SPB Number: 2024.0104
ELECTRICAL AND LIGHTING UPDATES
 [X] All RW Stores

Issued: 05/10/2024

STANDARD PLAN BULLETIN NOTICE
RaceWay Engineering and Construction Division

- Sheets: E111
- Attachment: E111

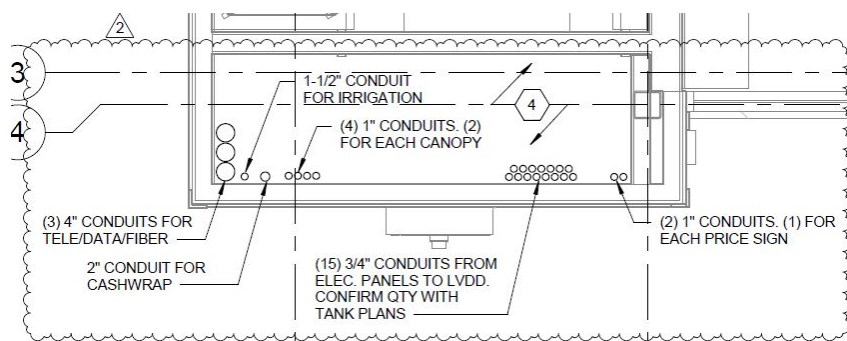
- E600 CONDUIT UPDATES:** On data closet, conduits to be shown on E111, and coordinate notes from 3/E600 to E111. General Note #4 added.

- Sheets: E110
- Attachment: E110

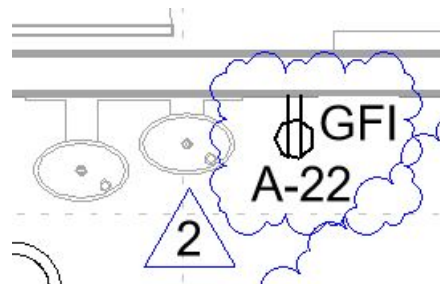
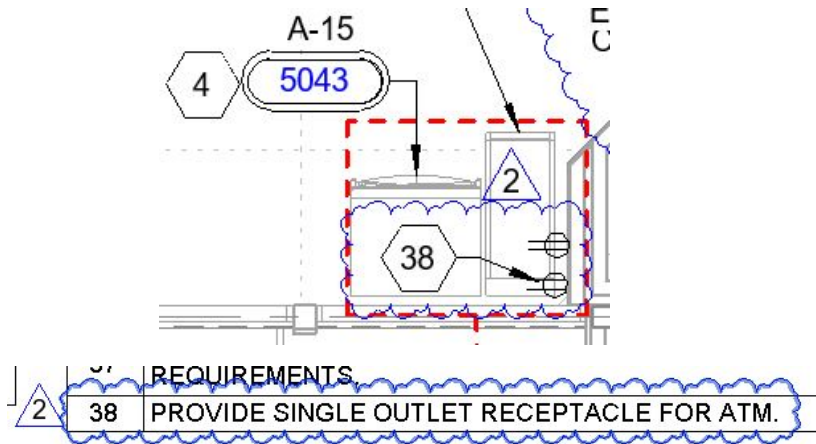
4. **OUTLET UPDATES:** Added note to provide single outlet receptacle for ATM. Added duplex near edge of water fountain.

- Sheets: A150
- Attachment: A150

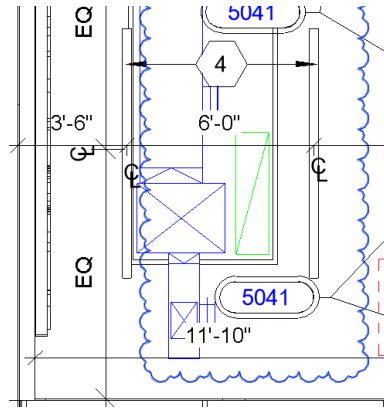
5. **LINEAR LIGHT UPDATES:** Added key note #4 to call for all suspended linear light fixtures to be mounted at 10'-6" in lieu of 11'-0".

4	LIGHTS TO BE MOUNTED 10'-6" A.F.F.	2.	F
	BRONZE BRACKET METAL PROVIDED AND INSTALLED BY G.C. TO	3.	S
